SBK-L-21023

Seabrook Station Radiological Emergency Plan (SSREP), Revision 77

**Enclosure 1 to SBK-L-21023**  
**Summary of Changes**

**Radiological Emergency Plan (SSREP), Revision 77**

SEABROOK STATION RADIOLOGICAL EMERGENCY PLAN	LOCATION OF EMERGENCY OPERATION CENTERS AROUND THE SEABROOK STATION SITE	
	SSREP REV. 57	FIGURE 6.1

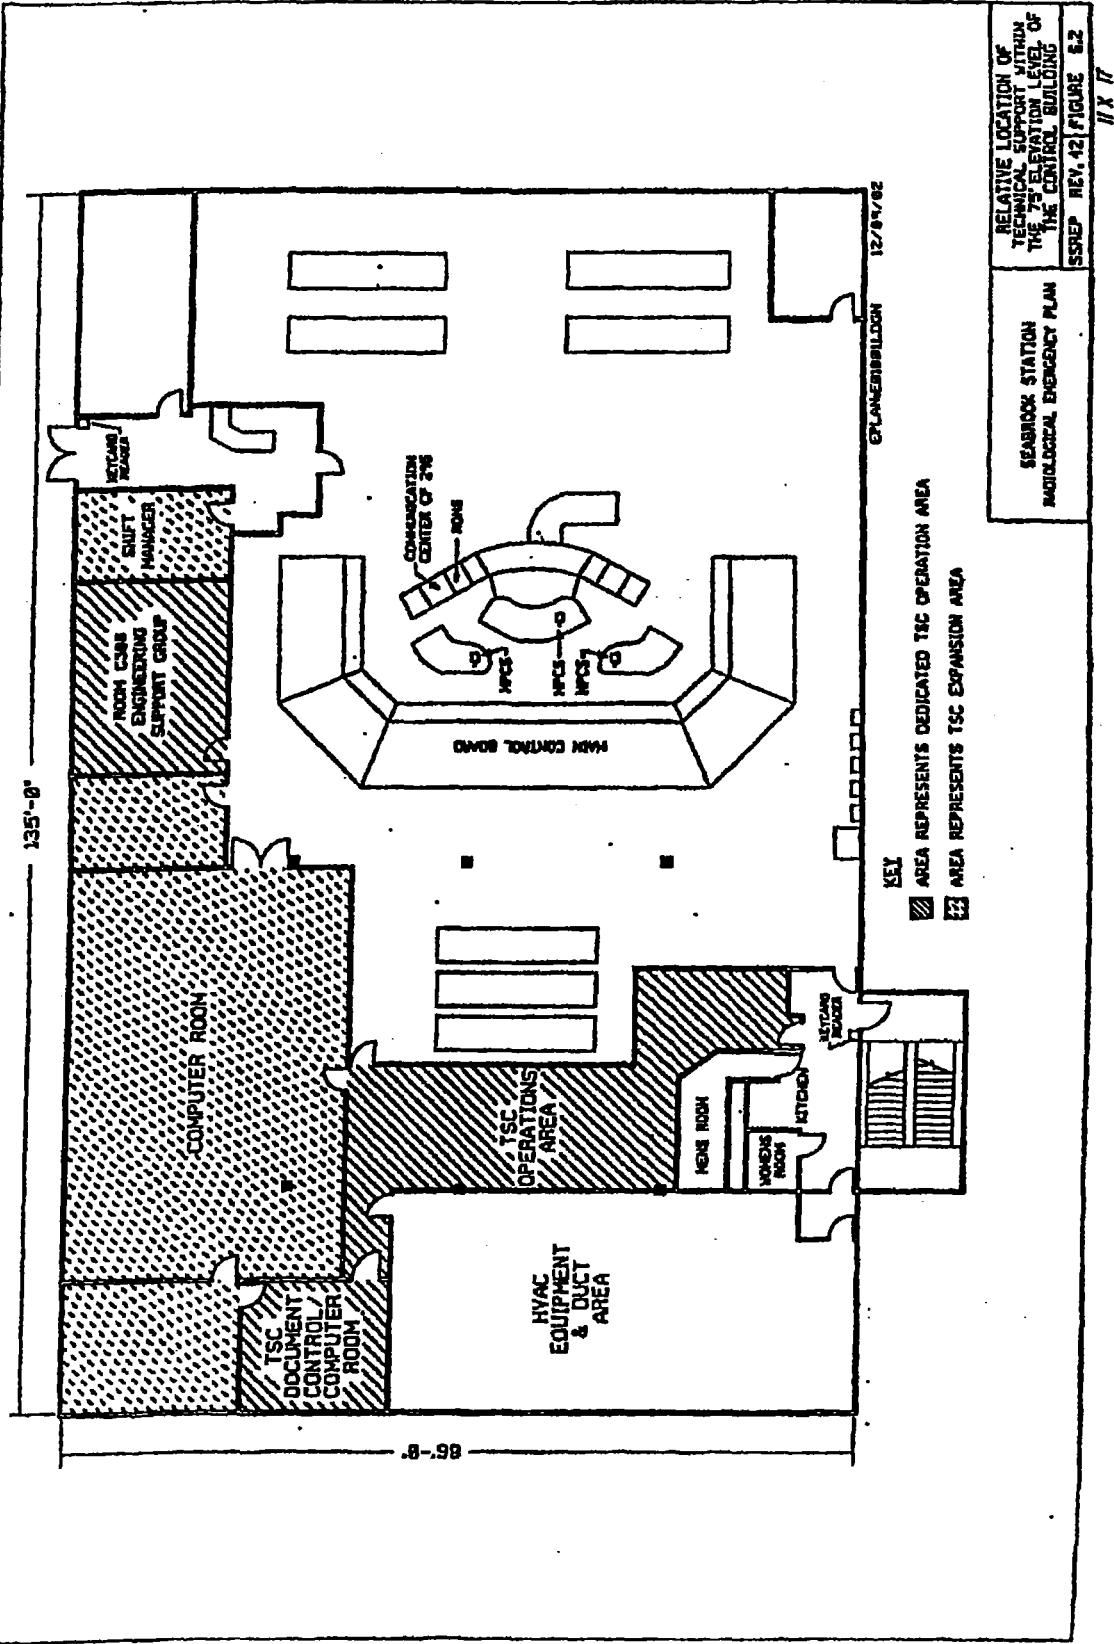
The EOF changed locations in 2013 and the SSREP was revised (AR 1721945) to reflect the new location in Portsmouth NH. This editorial change corrects the EOF location in Figure 6.1 that was inadvertently missed during the 2013 revision and is not associated with a planning standard.

Figure 6.1 - Corrected location of Emergency Operations Facility.

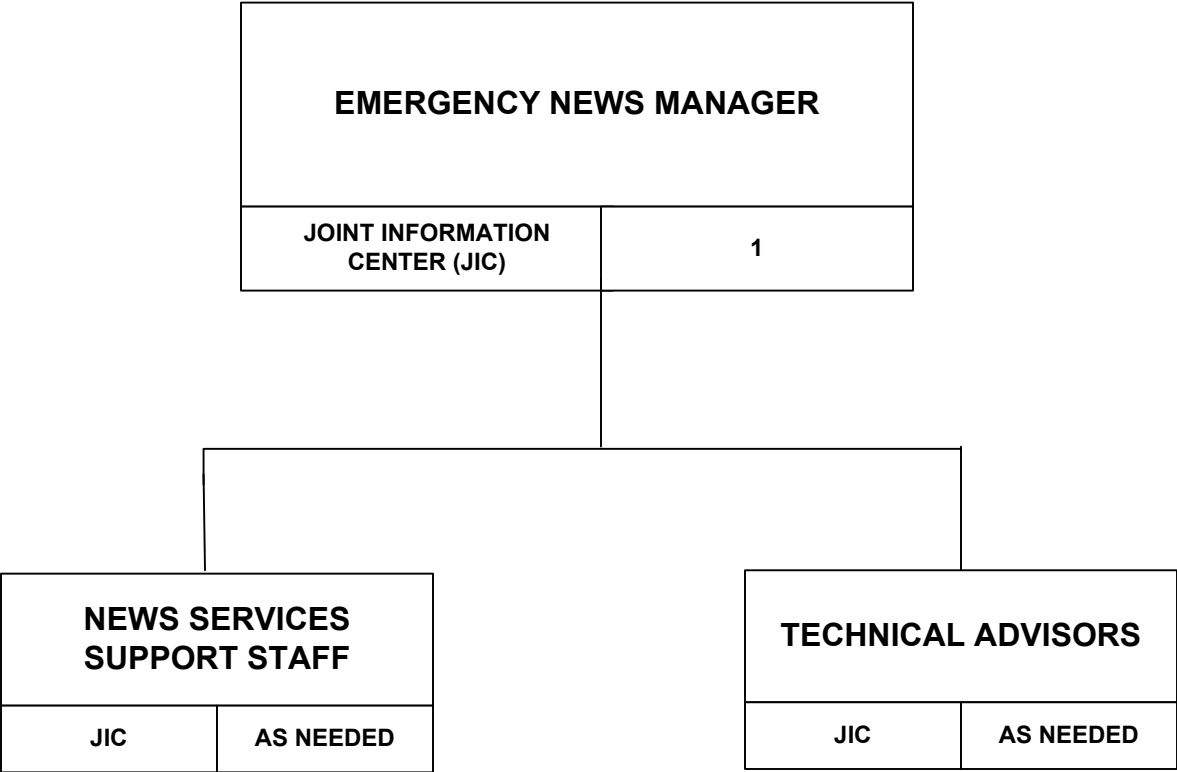
**Revised the location of the Seabrook Station News Services from the Science and Nature Center to the Joint Information Center or as directed by the Emergency New Manager -**

The Seabrook Station News Services activates during an Unusual Event. The Emergency News Manager may operate from any location and may request technical or administrative support at their discretion. The Science and Nature Center was viewed as a suggested facility to operate from; however the Joint Information Center is preferable since in the event of an emergency upgrade the Emergency News Manager would already be in their assigned facility. Only the Emergency News Manager is required to respond to the Unusual Event, while the Technical Advisor and Support Staff respond as needed. Figure 8.16 revised the number of Technical Advisors from 1 to “as needed” to match the Support Staff requirements.

**Revised number of Technical Advisors to “as needed” -**

Corrected number of JIC Technical Advisors from 2 to 1. In the SSREP revision 76 the JIC Technical Advisor position was reduced from 2 to 1. The JIC organizational chart was correctly revised however the JIC Technical Advisor position is also listed on the EOF organizational chart and was missed. The reduction in JIC staff was previously presented to and approved by ORG (ref. ORG meeting #19-18 AR 2330818).

Figure 8.16 – Revised the location of the Seabrook Station News Services from the Science and Nature Center to the Joint Information Center or as directed by the Emergency New Manager. Revised number of Technical Advisors to “as needed”.

Response may be to the Joint Information Center or as directed by the Emergency News Manager
